RE: DRAINAGE PLAN FOR ALBUQUERQUE NATIONAL BANK OPERATIONS CENTER

RE: DRAINAGE PLAN FOR ALBUQUERQUE
NATIONAL BANK OPERATIONS CENTER
S01-224-18

DRAINAGE PLAN

ALBUQUERQUE NATIONAL BANK OPERATIONS CENTER

Figure 1 - Parking Lot Cross Sections
Scale Horiz 1" = 40'
Vert 1" = 2'

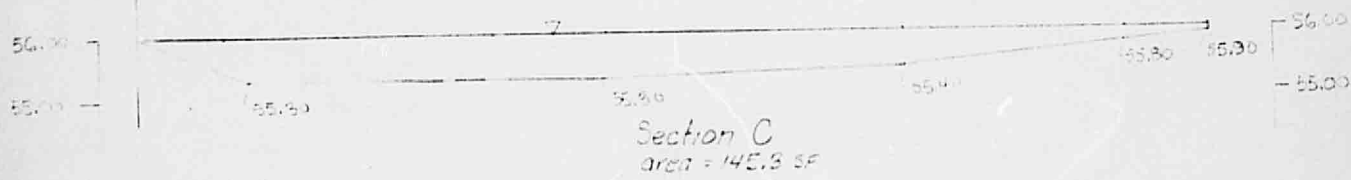
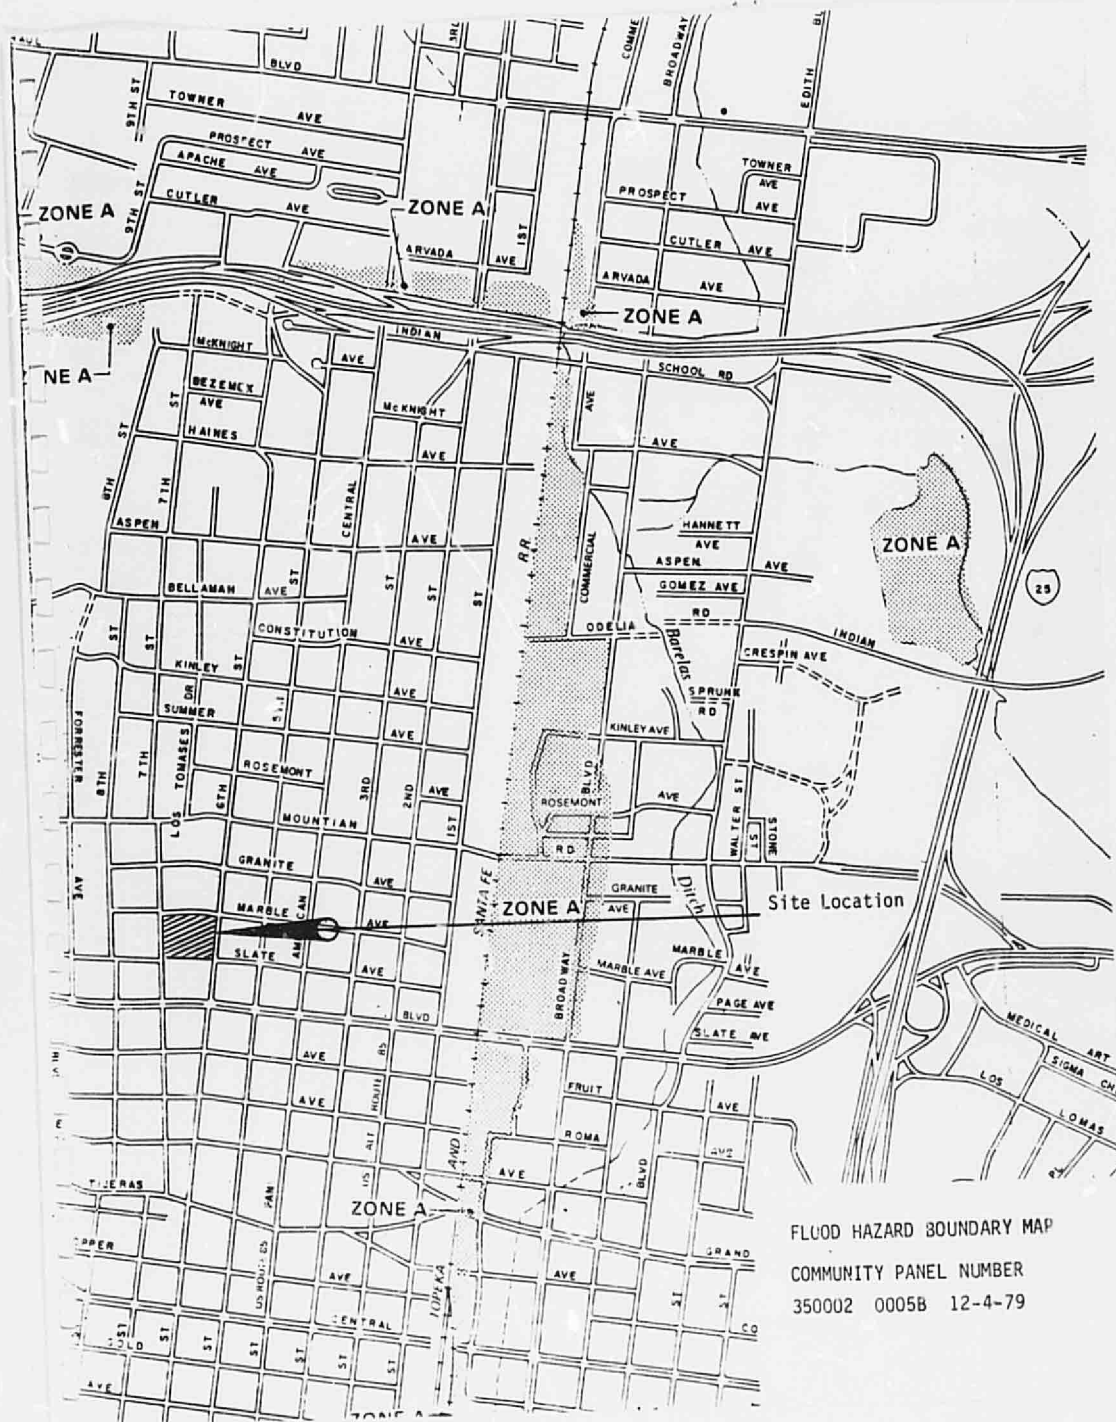
1. Please identify the 100-year ponding limit on the plan.
2. Please call out the orifice plate on Section A-A of the Catch Basin detail.
3. Can the finished floor elevation of the existing building be used as a temporary bench mark?
4. Approved copies of Special Order No. 19 for the storm drain connection must be placed in the City construction sets prior to release of the building permit.

1. The 100-year ponding limit has been identified on the plan.
2. The orifice plate has been called out on Section AA of the catch basin detail. Also, it has been shown to apply only to the southern catch basin.
3. The finished floor elevation of the existing building has been referenced as a temporary bench mark. The south entrance was actually used as a T.B.M.
4. Approved copies of the Special Order No. 19 have been placed in the City construction sets. An approved copy is attached for your information.
